INTERIOR RENOVATIONS + DORMER ADDITION + DECK ADDITION: TORRES RESIDENCE

RE: Torres (PB22-26)

Bulk Variance Review No.1

Re: *Torres (PB22-26)*
Bulk Variance Review No. 2
Location: 148 Bayside Drive
Block 1, Lot 7
Zone: R-3 (Residential District)
Borough of Atlantic Highlands, Monmouth County, NJ
Our File: HAHP0001.04

1 PROPOSED SITE
A.001 SCALE: N.T.S.

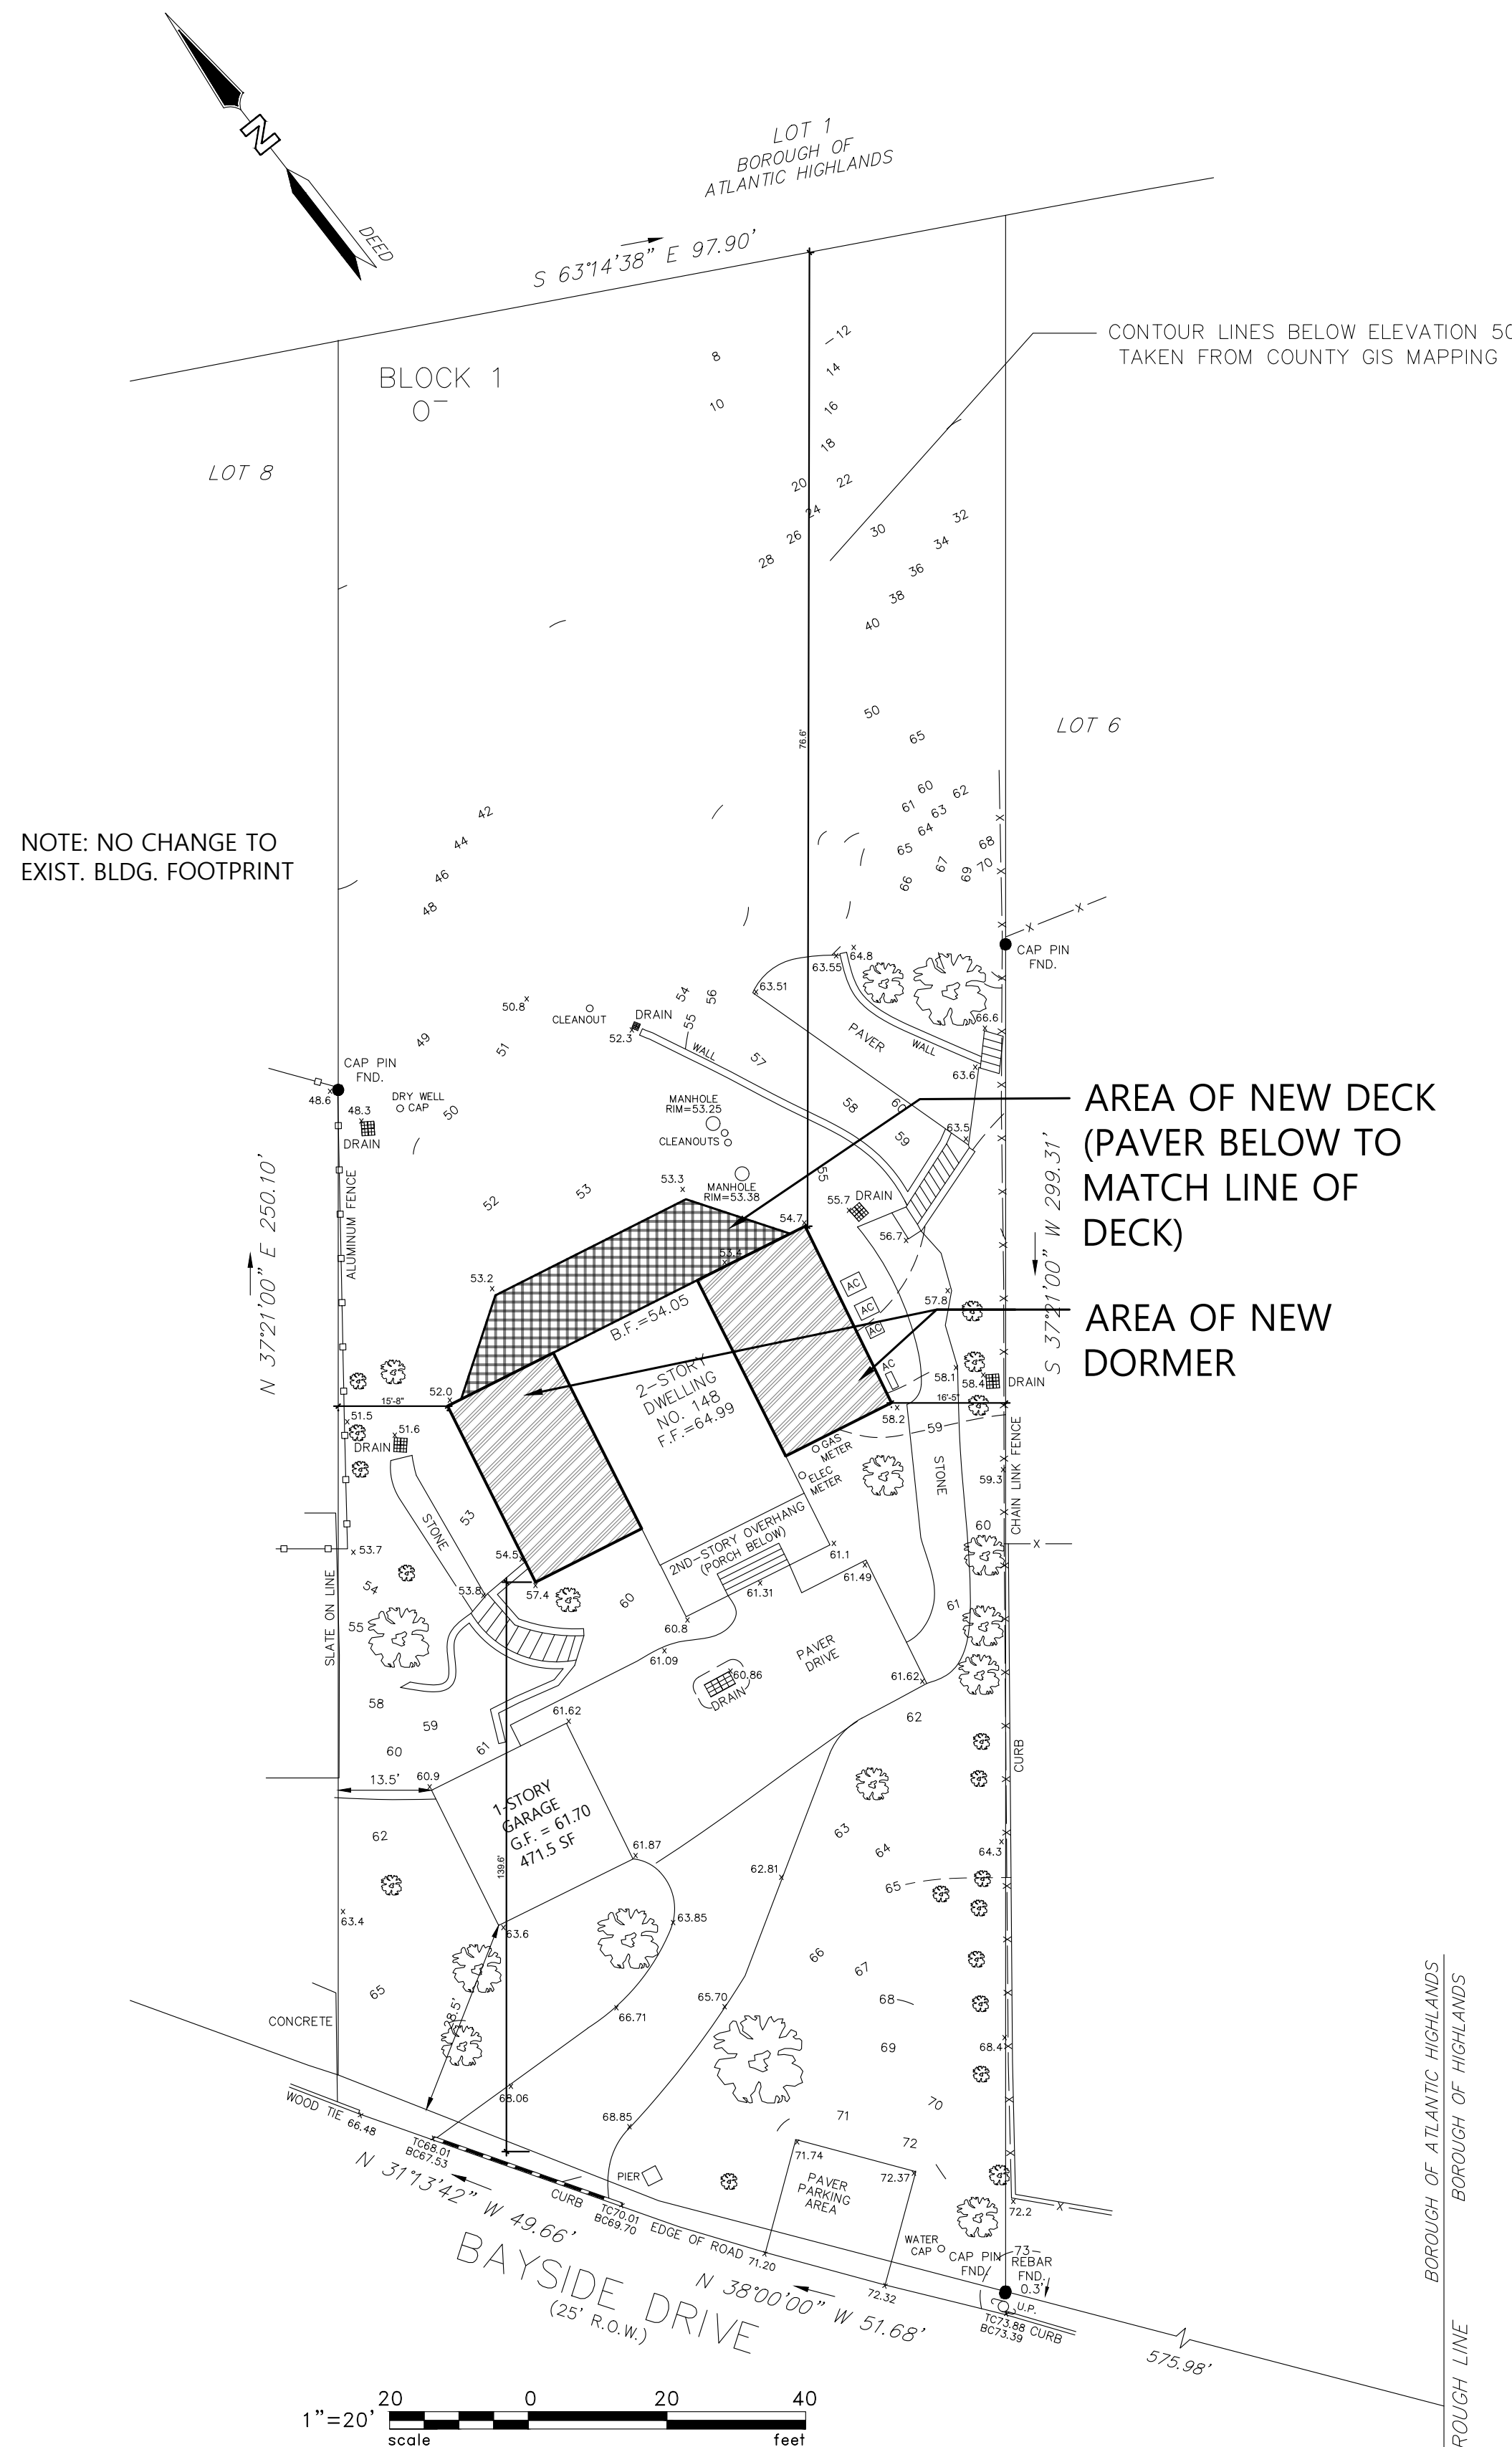
* Applicant specifies building coverage as 14 percent in both existing and proposed, however, plan scaling shows number to be 9.16 percent. Applicant to confirm.

- b) Several inconsistencies exist between the zoning tables provided. Applicant should clarify floor areas, lot coverage, building coverage, and accessory building height. We note the applicant requests a variance for building coverage (the area of a tract covered by buildings and roofed areas), however, our calculations show such a variance is not required. Applicant to confirm. We recommend any approval, if granted, be conditioned upon submission of a plan that reconciles all inconsistencies.

STEEP SLOPE ANALYSIS & SITE PLAN

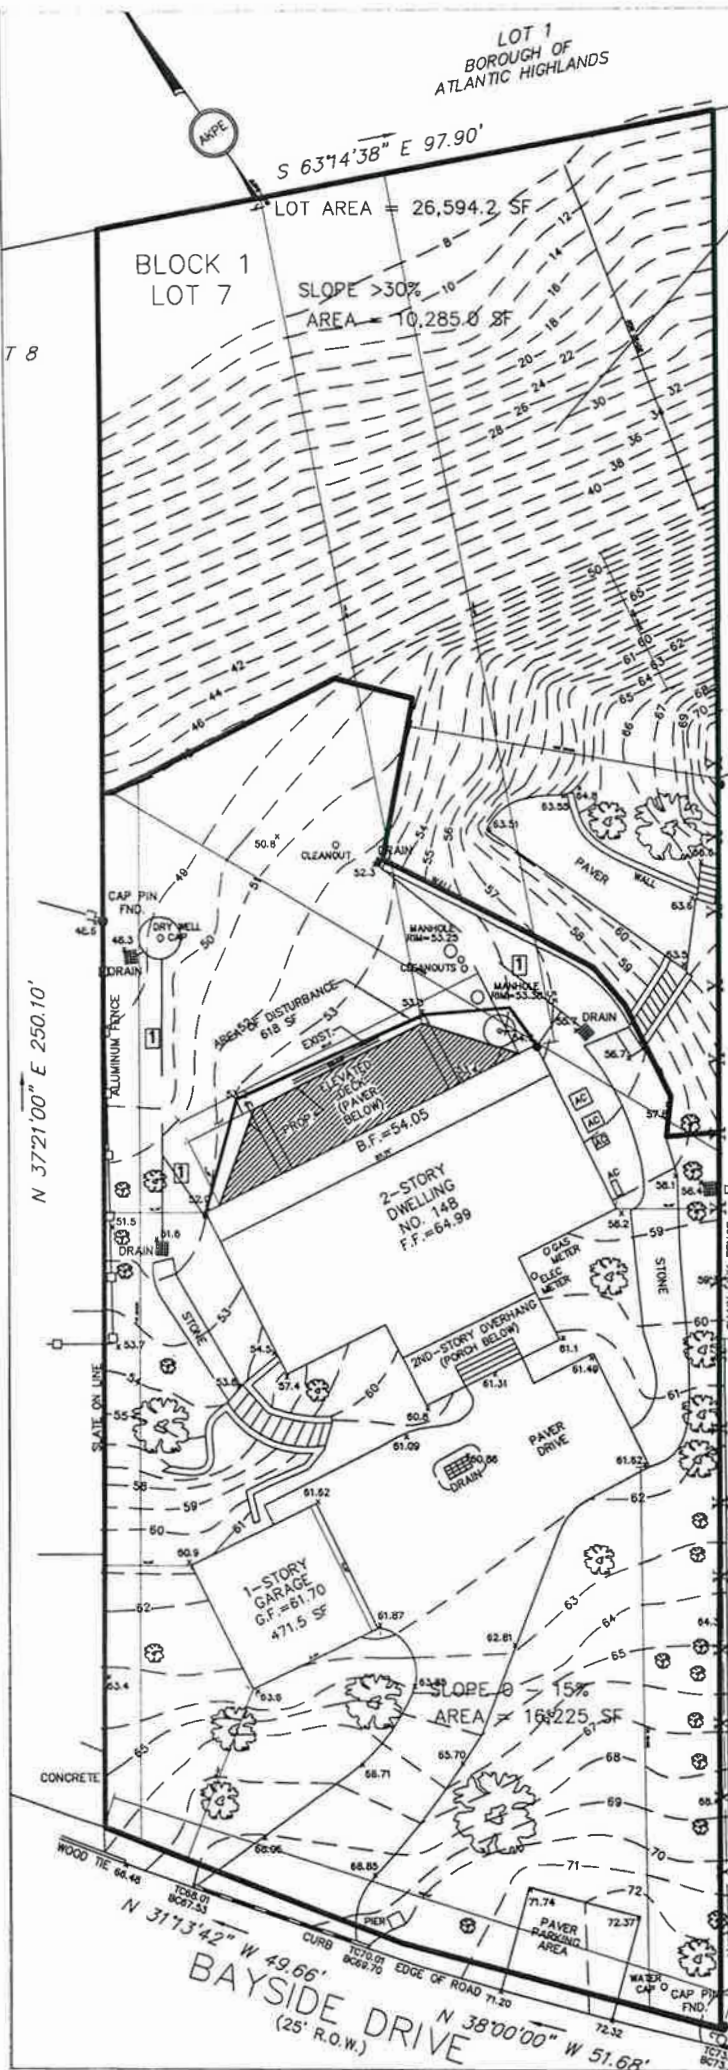
- a) Based upon our review of this application we find that the proposed improvements will meet the numeric requirements of Steep Slope Application, per Ordinance Section 150-78.E. A summary of the approximate allowable steep slope areas is provided in Table 1 below as calculated by the Applicant’s surveyor.

- d) Applicant should demonstrate compliance with the steep slope requirements of Ordinance Section 150-78 and specifically discuss runoff. Applicant should provide testimony on the existing stormwater system, including discharge point and drywell, and address concentration of flows and effects on adjacent properties. We note the property includes steep slopes exceeding 75 percent in the rear and recently was subject to erosion and slumping. Applicant should discuss how stormwater runoff is conveyed down the slope and how runoff from proposed additional impervious area will be mitigated. Should any portion of the post developed lot impact drainage conditions on the subject property or adjacent properties, the Applicant will be required to correct any deficiencies to the satisfaction of the Borough Engineer.

1. A steep slope analysis was done and a plan with analysis and calculation results is attached.
2. Newly completed Variance application is attached.
3. Volume of ground floor is 16,655 cf. Volume above grade is 12,629 cf. Percentage of story above ground is 78% . Additionally, first floor of house is more than 3 ft above grade and there are bedrooms on the lowest level. This is an existing use and condition.
4. Site plan for the steep slope analysis is based on the latest survey of the property signed sealed by the surveyor.
5. Steep slope plan shows all proposed exterior improvements and is scalable.
6. The existing detached garage is one story high and 471.5 SF. It has electricity.

With the steep slope calculation, revised zoning analysis and amended it appears that the side yard setbacks are no longer an issue. The non-conforming issues that remain and are existing are bulk variance and number of stories.
